Former Novartis Site, Parsonage Road, Horsham ('Phase 3').

On behalf of our Client, Muse, please find enclosed an application for a 'non-material amendments' ('NMA') pursuant to Section 96A of the Town and Country Planning Act 1990 (as amended) in relation to planning permission reference DC/25/0415 dated 16th January 2026.

This application relates to **Condition 1 ('Plans Condition')** and **Condition 7 ('Surface Water Drainage')** attached to the planning permission and seeks to amend the drafting of those conditions.

Extent of land that will be offered for adoption.

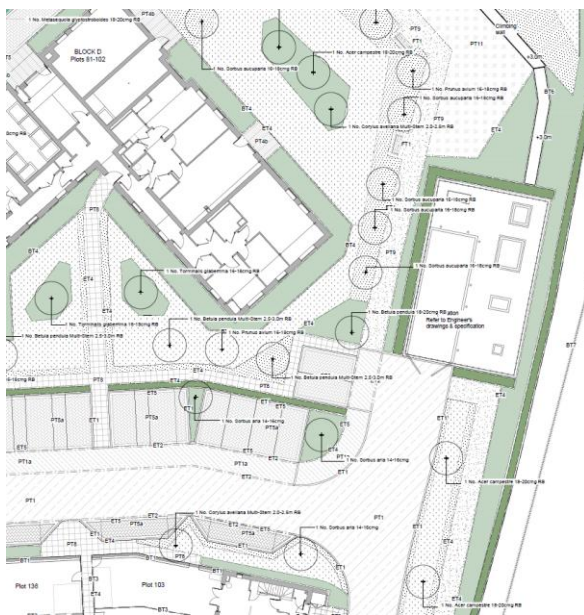
The layout of the scheme as consented was not designed to meet adoptable standards. That is because at the point that it was designed, it was not anticipated that any of the internal highway network or the site drainage infrastructure would be offered for adoption; rather, they would be managed privately. As you are aware, discussions are at an advanced stage between the Applicant and a leading Registered Provider, that it is anticipated will deliver the site as 100% affordable housing. The Registered Provider requires that a portion of the internal highways network and the entirety of the drainage infrastructure is offered up for statutory adoption. The parts of the site that will be offered for adoption, therefore, need to meet adoptable standards.

A plan extract showing the extent of the internal highway that will be offered for adoption is shown below, with the blue colouring denoting the adopted land:
